HISTORIC AND DESIGN REVIEW COMMISSION

HDRC CASE NO: 2018-589
ADDRESS: 611 N ST MARYS
LEGAL DESCRIPTION: NCB: 401 BLK: 1 LOT: N 68.8 FT OF E 101.28 FT OF 6
ZONING: D, HS
CITY COUNCIL DIST.: 1
LANDMARK: American Sports Center
APPLICANT: Miguel Saldana/B&A Architects, Inc.
OWNER: Uri Villarreal, Craig Glendenning/UC210 LLC
TYPE OF WORK: Rehabilitation, egress additions, fenestration modifications, rooftop addition
APPLICATION RECEIVED: November 16, 2018
60-DAY REVIEW: January 15, 2019
REQUEST:

VOSS BUILDING REHABILITATION

HDRC SUBMISSION SET

1 EXTERIOR ELEVATION - EAST
3/16" = 1'-0"

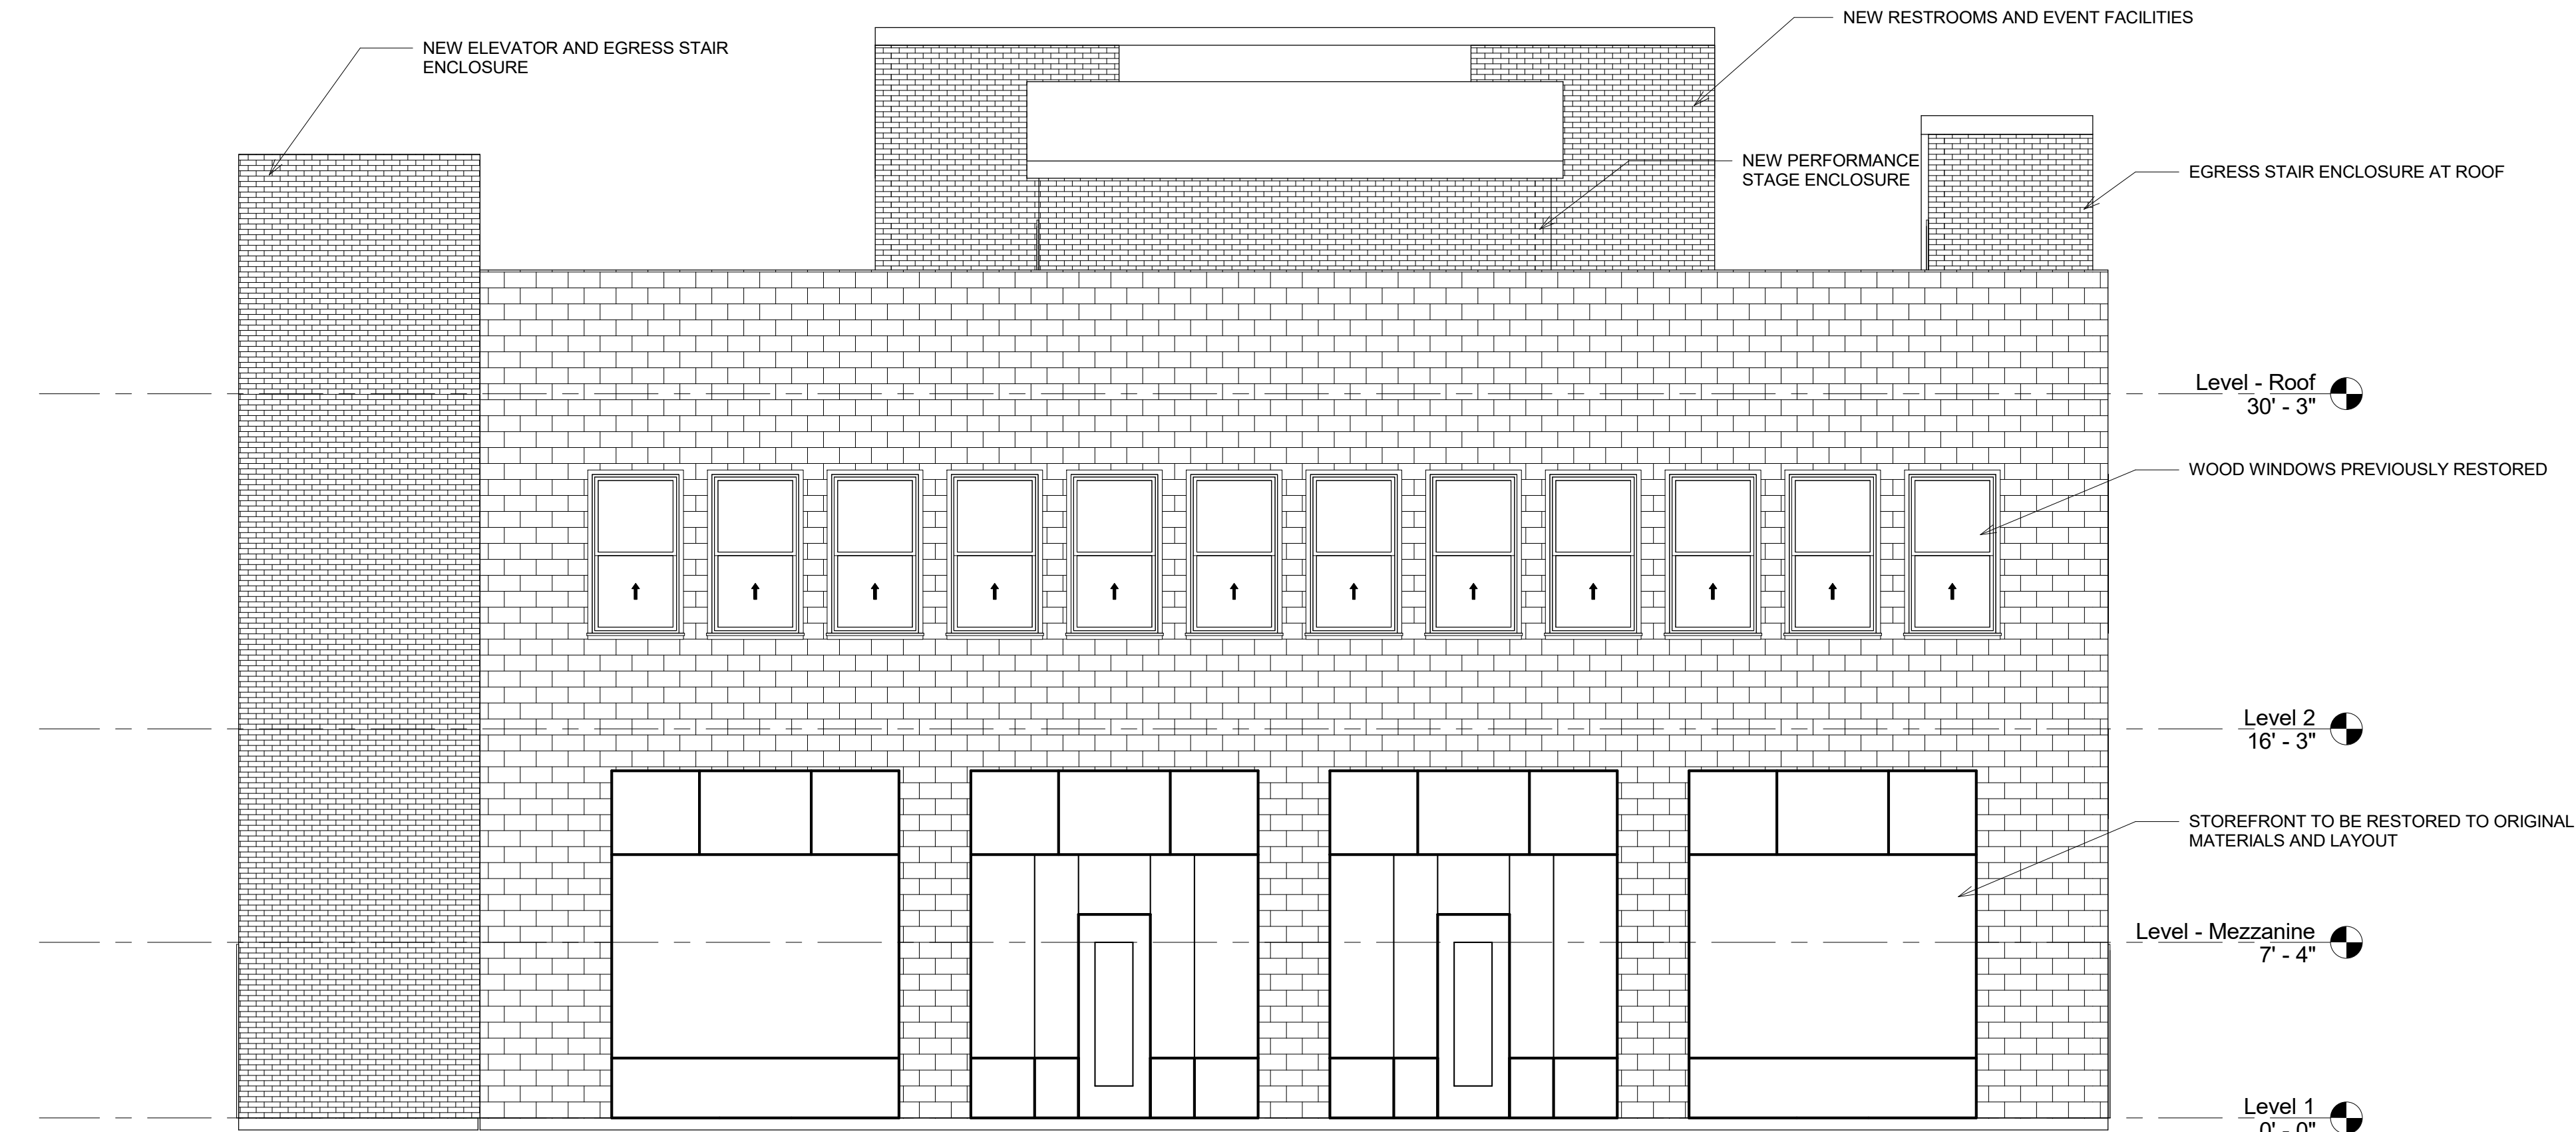
- c. STOREFRONT SYSTEM – The applicant has proposed to restore the structure's historic façade through the reconstruction of the wood storefront system. The Guidelines for Exterior Maintenance and Alterations 10.B.ii. notes that historic facades should be returned to their original design. Staff finds the proposed installation to be appropriate and consistent with the Guidelines; however, the applicant is to submit detailed construction documents and specifications for the proposed storefront reconstruction prior to receiving a Certificate of Appropriateness.

- d. TERRA COTTA – This historic structure originally featured decorative terra cotta elements, many of which have been damaged over time. The applicant has proposed to replace any damaged terra cotta elements with new to match the existing. This is consistent with the Guidelines for Exterior Maintenance and Alterations 10.A.iii.

- i. That the applicant submit specifications to staff for review and approval regarding the proposed storefront systems, terra cotta replacement materials and new steel windows as noted in findings c, d and f.

① EXTERIOR ELEVATION - SOUTH
3/16" = 1'-0"

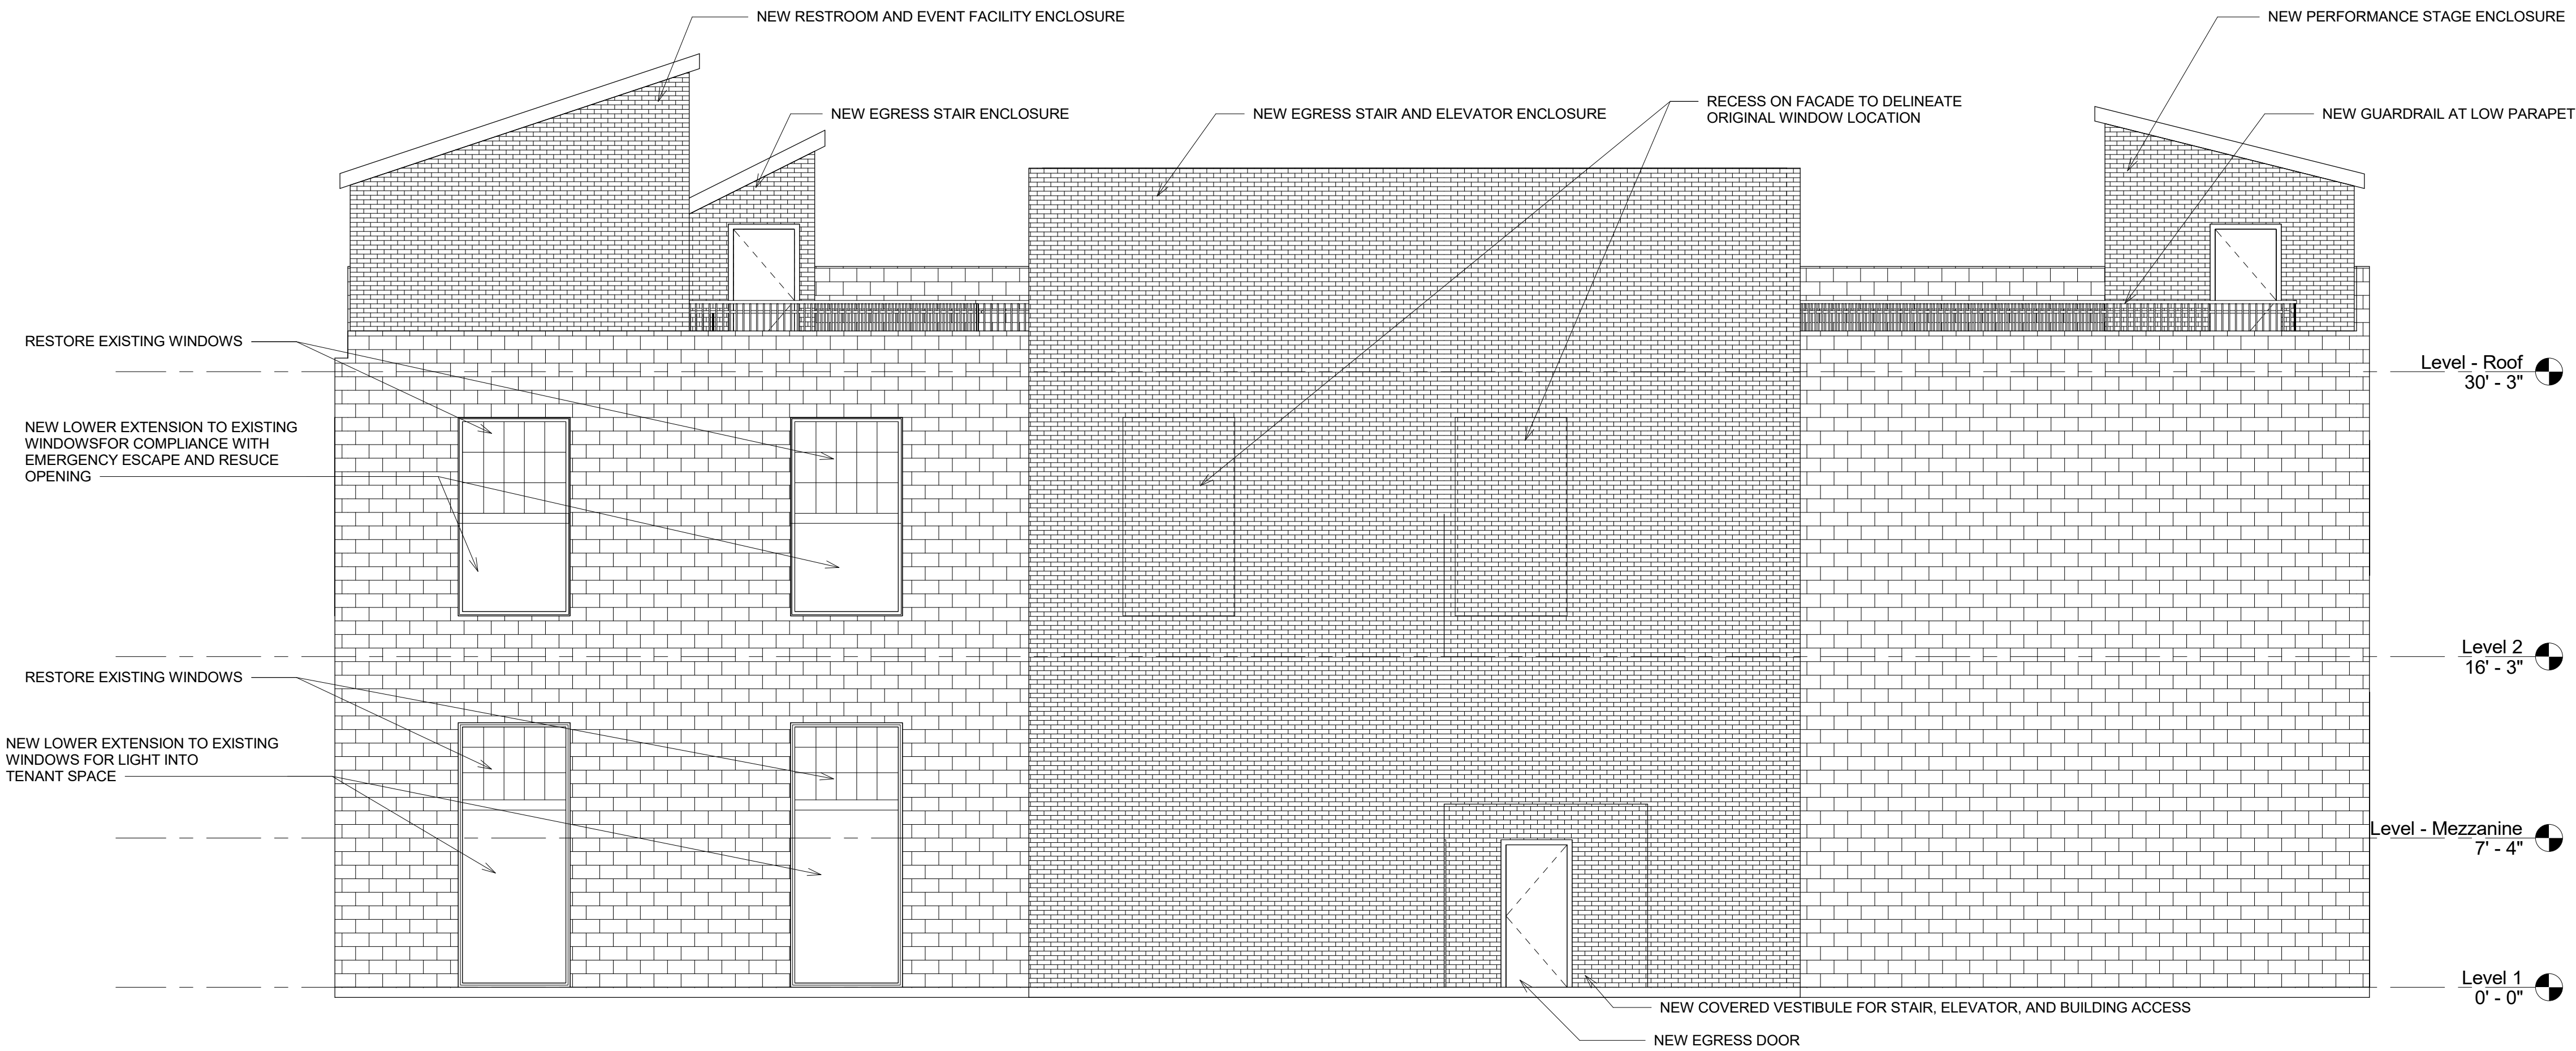
- e. FENESTRATION MODIFICATIONS – The applicant has proposed to enlarge existing window openings on the south façade to provide for emergency egress and additional natural light. The Guidelines for Exterior Maintenance and Alterations 6.A.i. notes that existing window and door openings should be preserved. The applicant has proposed to maintain the original head height and widths. While the applicant has proposed to modify an original opening, staff finds that it may be appropriate given the non-primary status of the façade.

- g. SIDE ADDITION – The applicant has proposed to construct an addition to the southern façade to house an egress stair and elevator addition. The proposed addition will feature a significant setback from the front façade and will feature brick cladding. Staff finds the proposed addition to be appropriate.

1 EXTERIOR ELEVATIONS - WEST
3/16" = 1'-0"

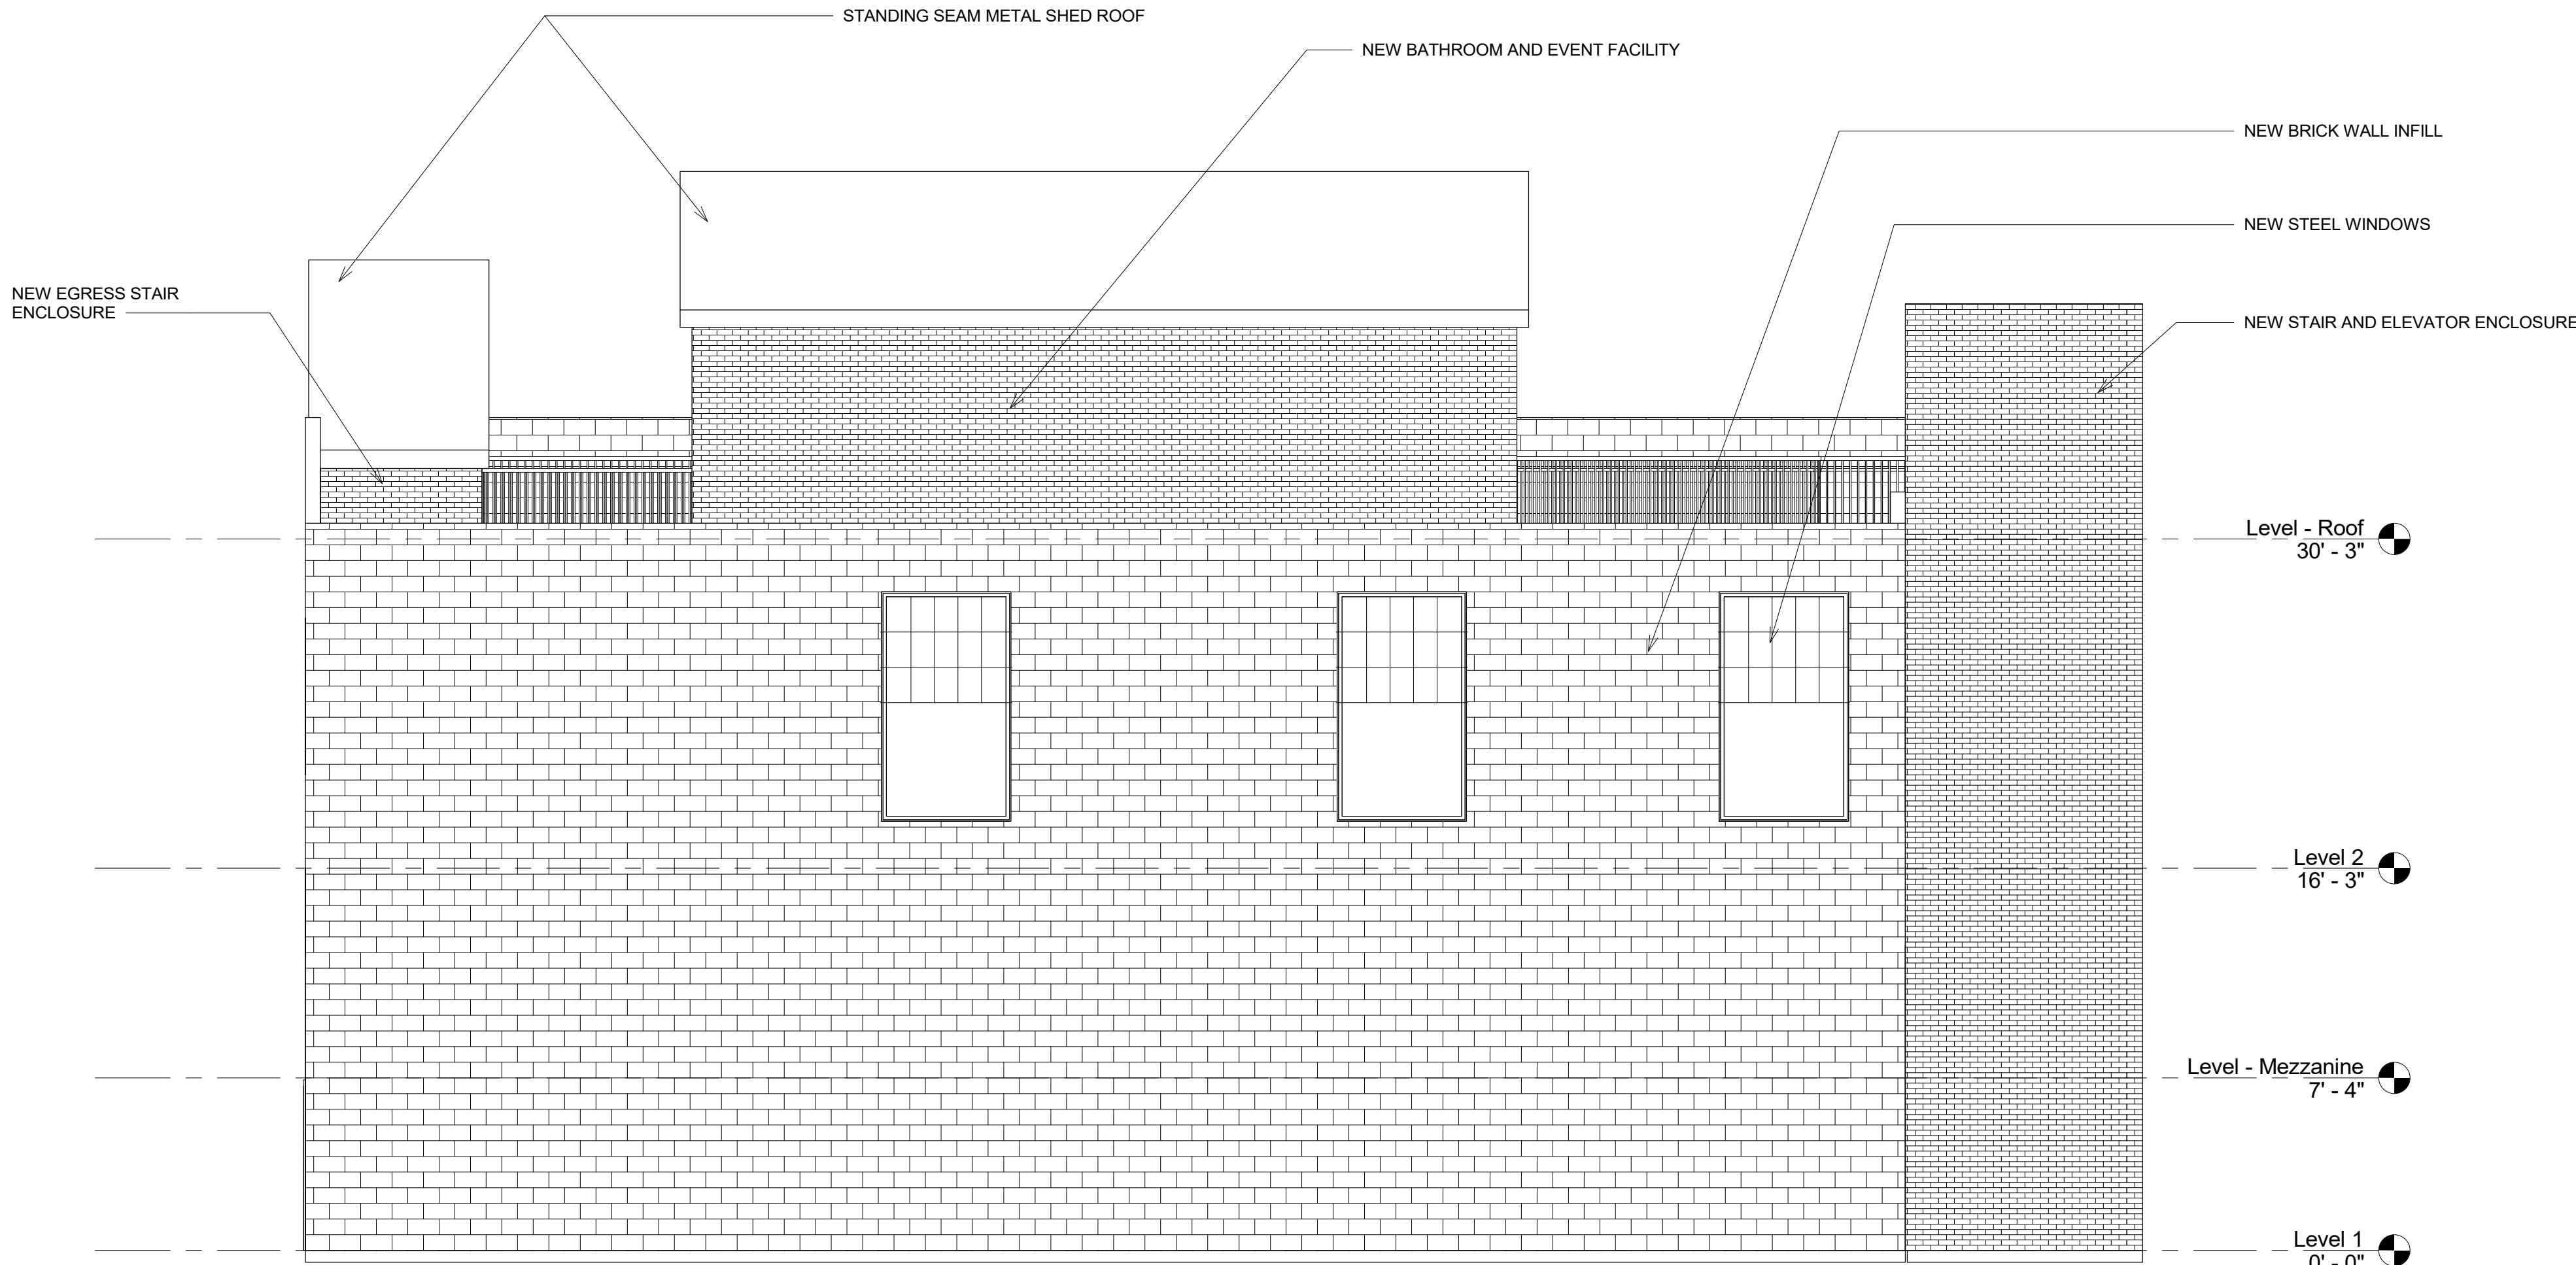
- f. EXTERIOR MODIFICATIONS – The existing west façade currently features infill materials consisting of CMU and other non-original masonry materials. The applicant has proposed to remove the existing infill materials and install brick. Additionally, the applicant has proposed to install three steel windows to match the profile of the proposed modified openings on the south façade. Per the Guidelines for Exterior Maintenance and Alterations 6.A.i., new windows should be avoided on the primary facades or facades visible from the public right of way. Given that the existing façade is void of fenestration and features variations in materials, staff finds the proposed window installations appropriate. Installation depth should match that of windows on the south façade. Additionally, window head and sill height should match those existing. The proposed steel windows are to be submitted to OHP staff for review and approval.
